From: Stewart, Patricia, NMENV
Sent: Monday, May 24, 2010 3:49 PM
To: Hugh Hanson (Hugh.Hanson.Ctr@cannon.af.mil)
Subject: FW: Scanned image from HWB.SCANNER

DRN BY: TSSM	DATE: 04/07/99	SAND TRAP AT POL WASHRACK - SWMU 127 SITE PLAN WITH BORING LOCATIONS CANNON AIR FORCE BASE NEW MEXICO	PROJECT NO.	FIG. NO.
CHK'D BY: .	REVISION: 0		45FM9602CC.00	7-2

CAFB SWMU 127 Dilemma

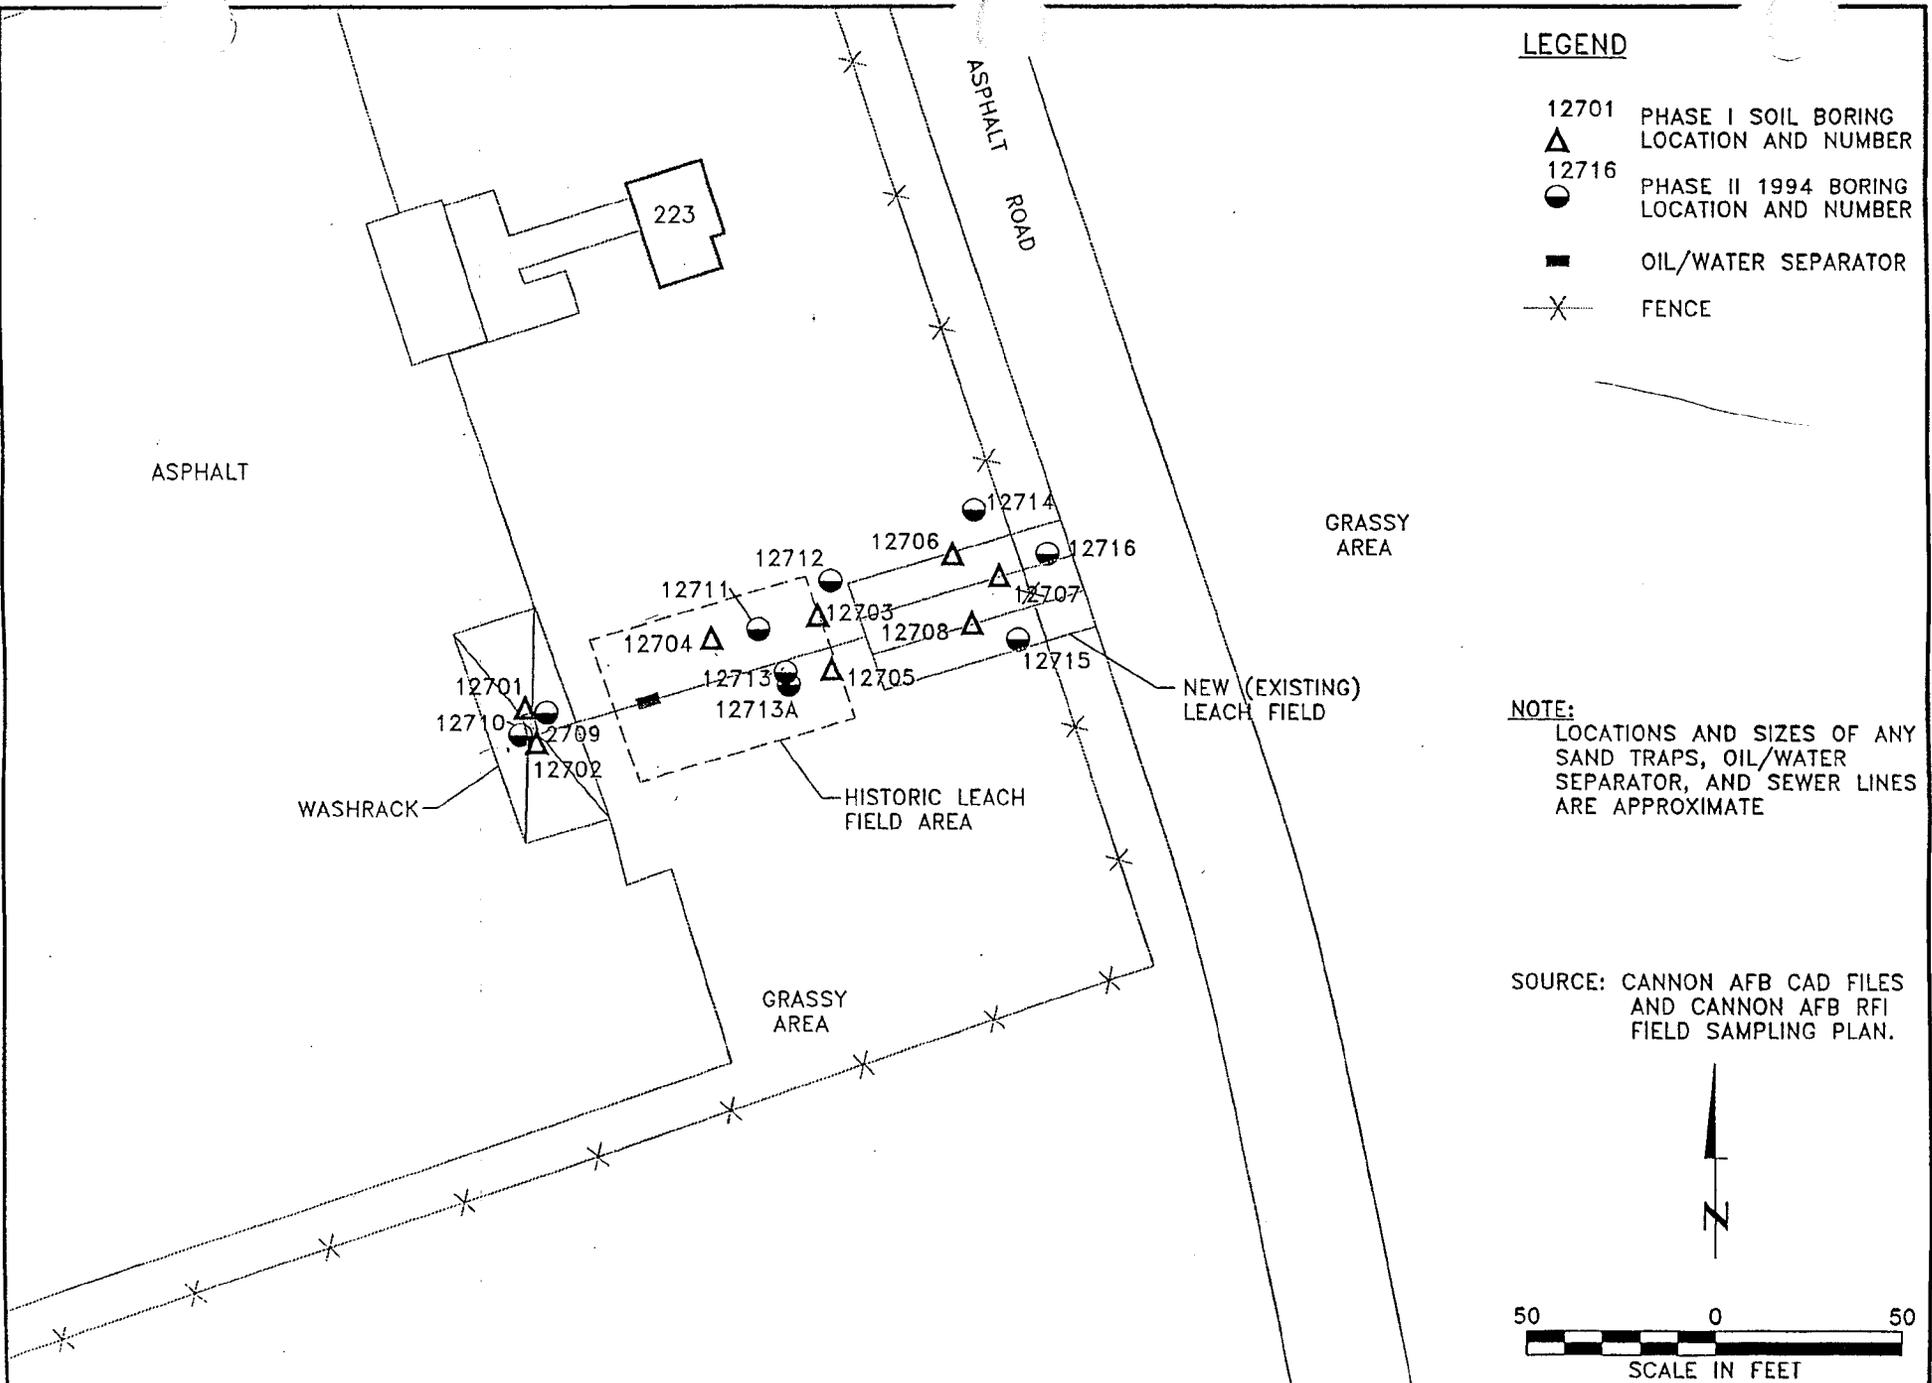
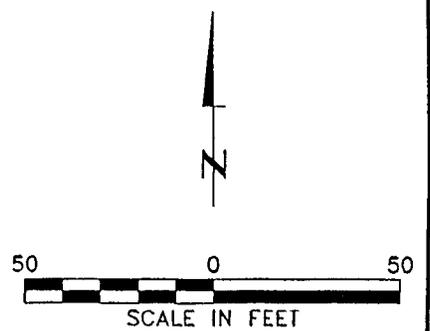
Please see the attached scanned image of Figure 7-2 from the Corrective Measures Study at SWMUs 31, 48a, 77, and 127, Cannon AFB. The figure identifies the wash pad, original leach field as well as an OWS and new leach field that were installed in 1991.
Hi Hugh:

Please see the paragraph in Section 1.2.2 SWMU 127 (page 2) in the Final Letter Report dated July 2008. The last sentence states, "During a visit to the site on August 6, 2007, the wash pad was inspected and an interview with Base personnel indicated that the wash pad had recently been in use."

Can you confirm when the wash pad was last used? What are the current and planned future uses of the site?
